**WORKPLAN
FOR ADDITIONAL SUBSURFACE INVESTIGATION
AT THE AC TRANSIT 1177 47TH STREET FACILITY
EMERYVILLE CALIFORNIA**

**Prepared By:
Safety-Kleen Consulting
2233 Santa Clara Avenue
Alameda, California 94501
510/337-8661
8660
August 8, 2000**

Subject: Workplan for Additional Subsurface Investigation
AC Transit, 1177 47th Street, Emeryville

FIGURE 1
AC TRANSIT - PROPOSED BORING MAP

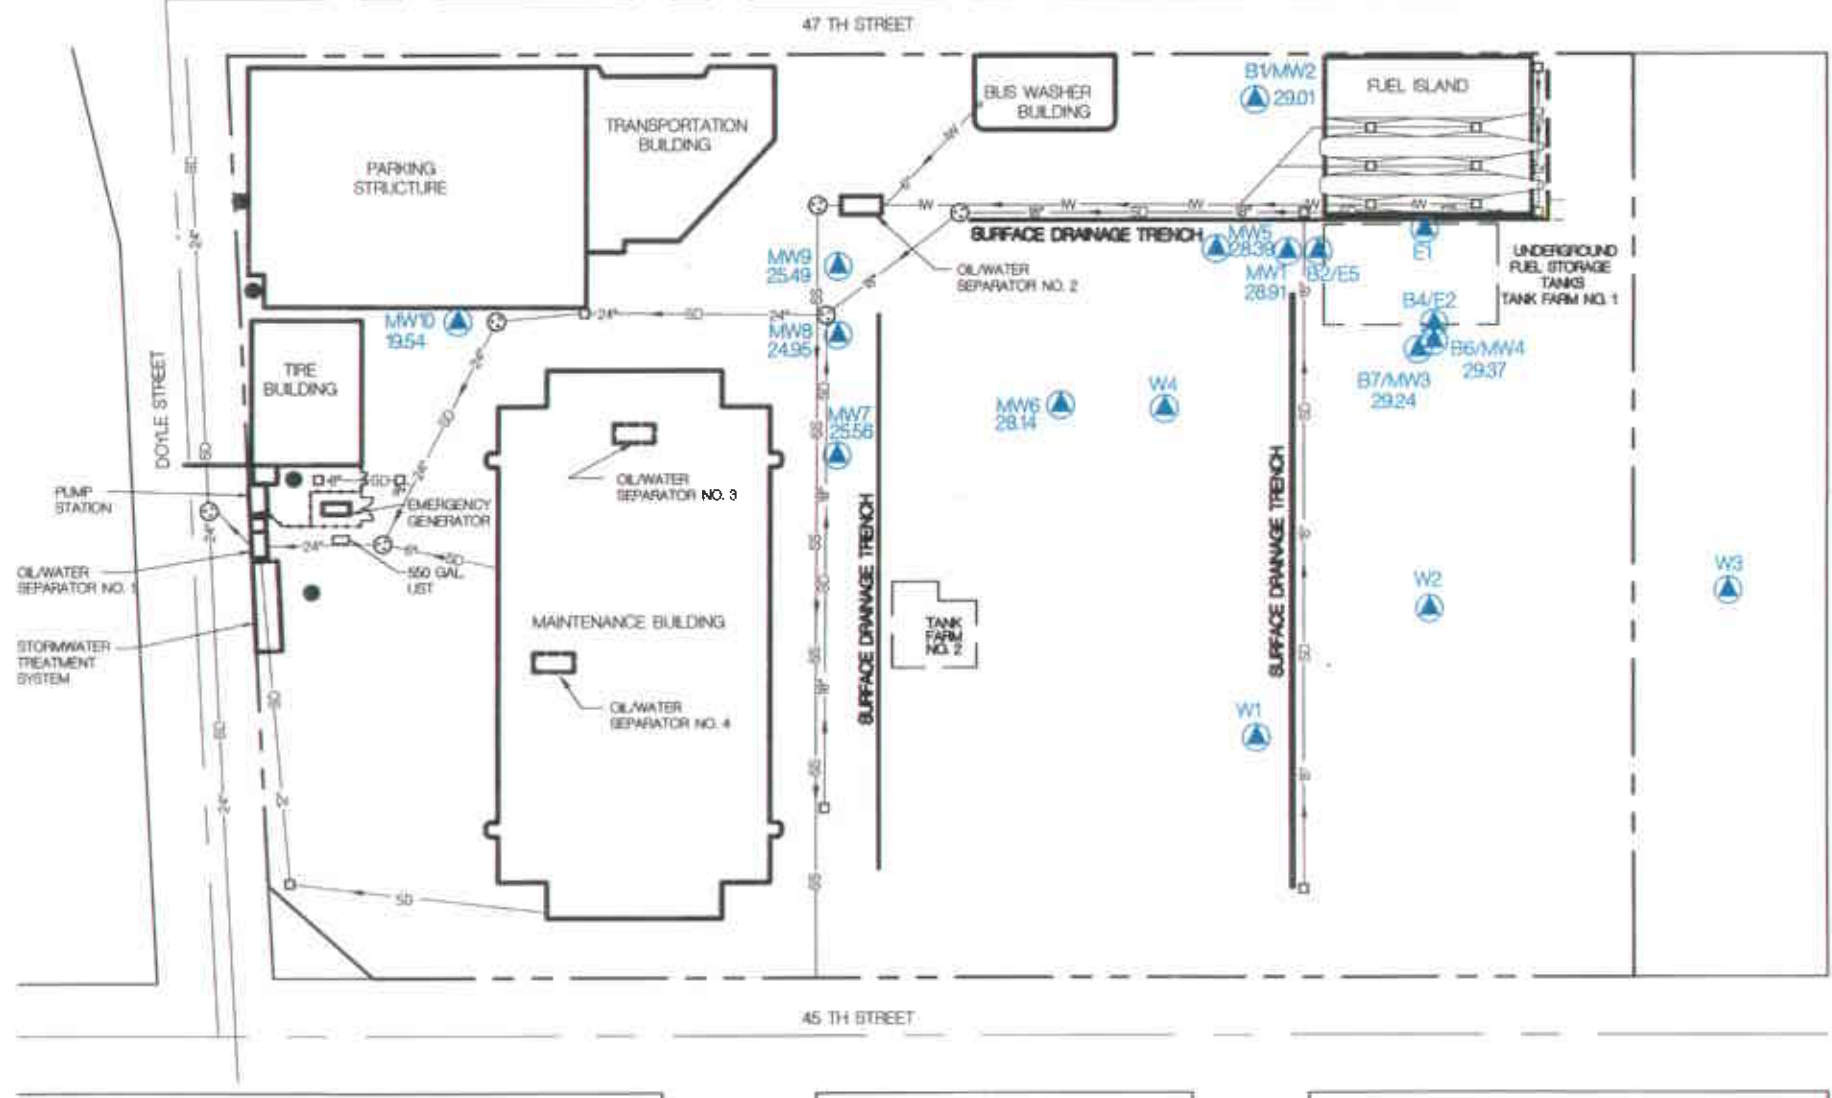
- What about soil sampling +
GW sampling in vicinity of
tank farm 2
- should bongs be closer
to storm drain / backfill?
- Is aquifer confined?
or should new wells be
screened 4-15' bgs?

*Collect a soil sample from one of borings
at ~ 3' bgs (vadose zone) for TOC,
water content, bulk density, porosity.*
